Final Product/Process Change Notification

Document #:FPCN22686Z1

Title of Change:	Update to FPCN22686Z with reference to CASE 507AU issue A in the previous announced Through Slot Wettable Flank Solution for PQFN56 Punch Automotive.	
Proposed Changed Material First Ship Date:	16 Apr 2020 or earlier if approved by customer	
Current Material Last Order Date:	01 Jan 2020 <i>Orders received after the Current Material Last Order Date expiration are to be considered as orders for new changed material as described in this PCN. Orders for current (unchanged) material after this date will be per mutual agreement and current material inventory availability.</i>	
Current Material Last Delivery Date:	15 Apr 2020 <i>The Current Material Last Delivery Date may be subject to change based on build and depletion of the current (unchanged) material inventory</i>	
Product Category:	Active components – Discrete components	
Contact information:	Contact your local onsemi Sales Office or Peter.Lee@onsemi.com

BOTTOM VIEW

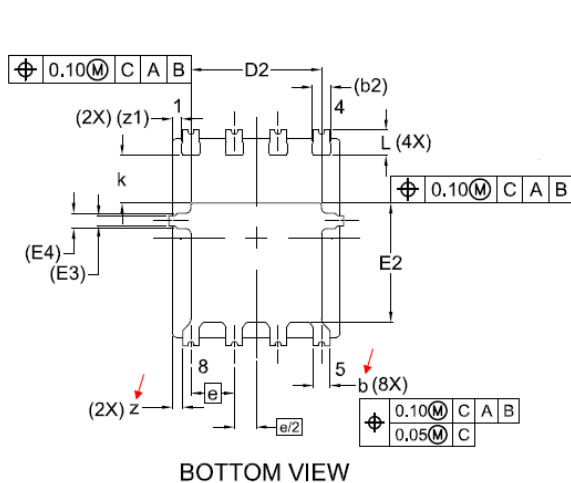
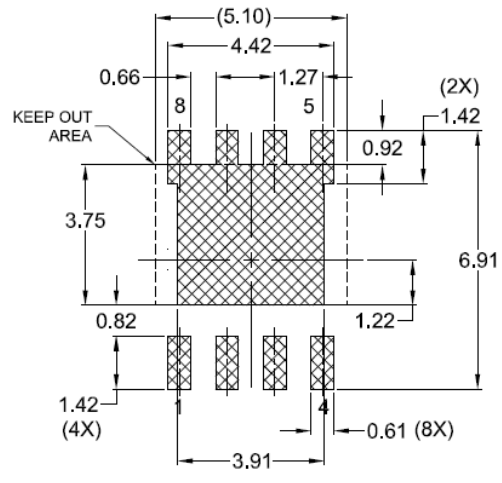
Change Category		
Category	Type of Change	
Process - Assembly	Change in leadframe dimensions	
Description and Purpose:		
Update to FPCN22686Z with reference to CASE 507AU issue A in the previous announced Through Slot Wettable Flank Solution for PQFN56 Punch Automotive.		
	From	To
LeadFrame	<u>Through Slot Wettable Flank</u> Dimension b: 0.49 ± 0.05 mm (lead width) Dimension z: 0.30 ± 0.05 mm (lead to package edge distance)	<u>Through Slot Wettable Flank</u> Dimension b: 0.52 ± 0.05mm Dimension z: 0.29 ± 0.05mm
Case outline dimensions that is affected by the change is highl ighted in Red color:

DIM	CASE 507AU Issue O			CASE 507AU Issue A		
	MIN	NOM	MAX	MIN	NOM	MAX
A	0.90	1.00	1.10	0.90	1.00	1.10
A1	0.00	-	0.05	0.00	-	0.05
A2	0.65	0.75	0.85	0.65	0.75	0.85
A3	0.30 REF			0.30 REF		
b	0.44	0.49	0.54	0.47	0.52	0.57
b1	0.13	0.18	0.23	0.13	0.18	0.23
b2	0.54			0.54		
D	5.00	5.10	5.20	5.00	5.10	5.20
D1	4.80	4.90	5.00	4.80	4.90	5.00
D2	3.72	3.82	3.92	3.72	3.82	3.92
E	6.20	6.30	6.40	6.20	6.30	6.40
E1	5.70	5.80	5.90	5.70	5.80	5.90
E2	3.38	3.48	3.58	3.38	3.48	3.58
E3	0.30 REF			0.30 REF		
E4	0.45 REF			0.45 REF		
e	1.27 BSC			1.27 BSC		
e/2	0.635 BSC			0.635 BSC		
k	1.30	1.40	1.50	1.30	1.40	1.50
L	0.64	0.74	0.84	0.64	0.74	0.84
z	0.25	0.30	0.35	0.24	0.29	0.34
z1	(0.28)			(0.28)		
θ	0°	---	12°	0°	---	12°
